## **REMARKS**

**AMENDMENTS TO THE DRAWINGS:**

FIG. 1

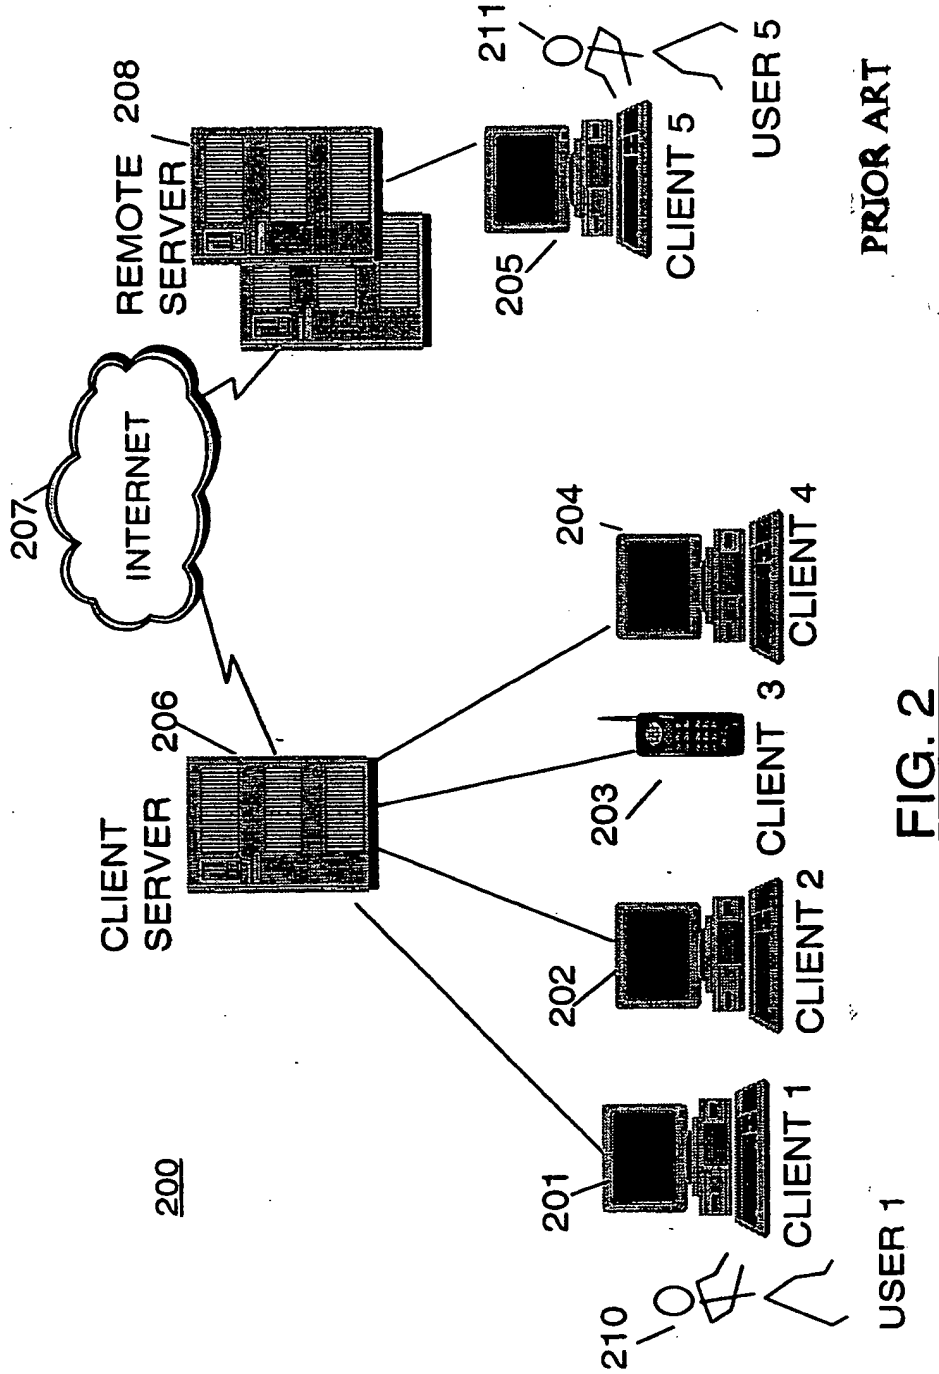
In objecting to the drawings, the Examiner noted that Figures 1 and 2 should be designated as "Prior Art," and that in Figure 3C, reference characters "326" and "327" have both been used to designate a network. The Examiner also noted that several reference characters shown in Figures 1, 2, 3C, 4, 6, 7, 8B, 10A, 10B and 10C are not mentioned in the specification.

In response, Applicants are submitting herewith corrected Figure 1 and 2, in which both of these Figures are labeled as "Prior Art." In addition, the specification is being amended to add the missing reference numbers from the Figures, care being taken to avoid adding new matter.

Please replace original Figures 1 and 2 with the corrected Figures 1 and 2 submitted herewith.
